Access Compliance Report

Public Rights-of-Way

(Curb Ramps)

Intersection ID: 4616	Main Street: ROZZELLES_FERRY_RD	Cross Street: MONARCH_DR	Location:	N
ADA ID: 6738DA313259	Ramp Type: BlendTrans2	Initial Pass/Fail: Fail	Overall Compliance: No	Severity Score: 1.25
Codes/Mitigation Info/Possible Solution		Field Measurements/Component Compliance

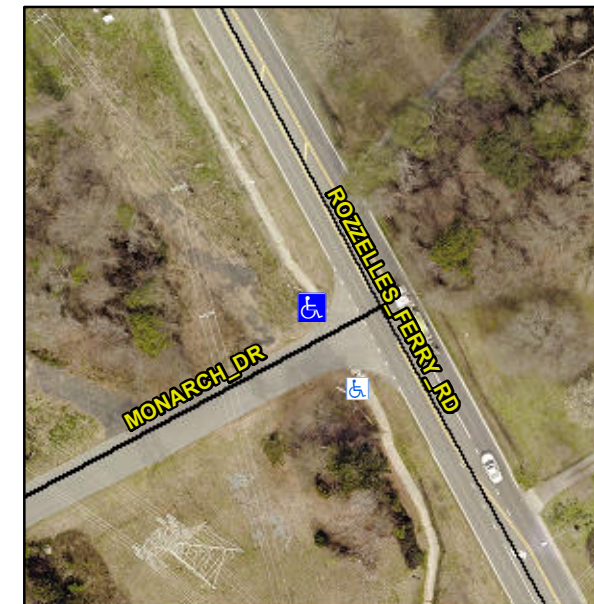
Compliance	Description	Data	Compliance	Description	Data
N/A	Ramp Length (in)	63.0	Yes	BlendTrans Slope (%)	0.6
Yes	Ramp Width (in)	64.0	No	BlendTrans XSlope (%)	2.1
N/A	Flare Type LT	N/A	N/A	Flare Type RT	N/A
N/A	Flare Slope LT (%)	N/A	N/A	Flare Slope RT (%)	N/A
N/A	Flare Traversable LT?	N/A	N/A	Flare Traversable RT?	N/A
N/A	Landing Length (in)	N/A	N/A	DWS Provided?	N/A
N/A	Landing Width (in)	N/A	N/A	DWS Contrast?	N/A
N/A	Landing Slope (%)	N/A	N/A	DWS Length (in)	N/A
N/A	Landing X Slope (%)	N/A	N/A	DWS Full Width?	N/A
N/A	Landing Curb? (Y/N)	N/A	N/A	DWS Offset (in)	N/A
N/A	Shared Landing?	N/A			
N/A	Gutter Ponding?	N/A	N/A	Gutter Slope (%)	N/A
N/A	Gutter Lip Ht (in)	N/A	N/A	Gutter X Slope (%)	N/A
N/A	Painted X Walk1?	No	N/A	Painted X Walk2?	N/A
	X Walk 1 Direction	To S		X Walk 2 Direction	N/A
	X Walk 1 Width (in)	N/A		X Walk 2 Width (in)	N/A
	X Walk 1 Slope (%)	1.9		X Walk 2 Slope (%)	N/A
	X Walk 1 X Slope (%)	2.7		X Walk 2 X Slope (%)	N/A

N/A	Ramp inside XWalk1?	N/A	N/A	Ramp inside XWalk2?	N/A
	Road Slope (%)	2.7		Clear Space?	N/A
	Road X Slope (%)	1.9	N/A	Clear Space to XWalk (in)	N/A
N/A	Any Obstructions?	N/A	N/A	Storm Grate/Utility Hazard?	N/A
	Obstruction Type			Storm Grate/Utility Type	
		N/A			N/A
			Yes	Surface Condition? (G/P)	Good
			N/A	Curb Slope (%)	0.1

Remove & Replace Curb Ramp With Two New Directional Ramps or Equivalent.
